Product Change Notification (PCN)

Document No. PCN-A-20240716 Revision 1.0

PCN TOPIC: FM14-V series Touch Screen Changes.

Original	New
Outlook		
Touch Controller	EETI EXC80W60	EETI EXC81W60

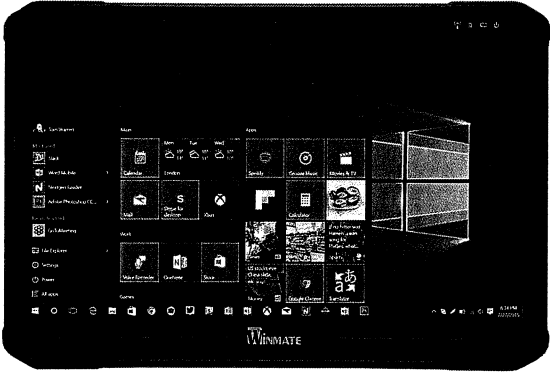
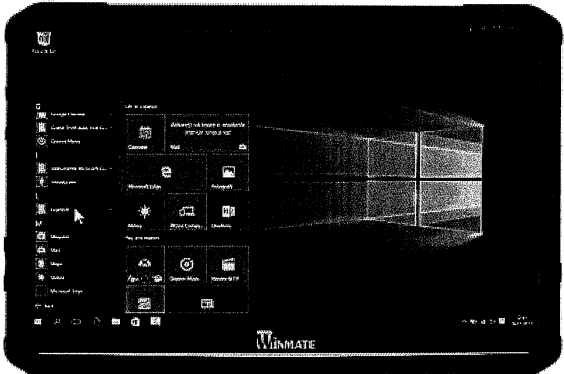
This is a notification of Touch Screen Printing design and Touch Controller change. For product longevity strategy, Winmate is going to introduce a new look on Touch Screen Printing and new touch controller. This change will not impact Motherboard, BIOS, Device Drivers nor Mechanical design. The Touch FW will be updated accordingly.
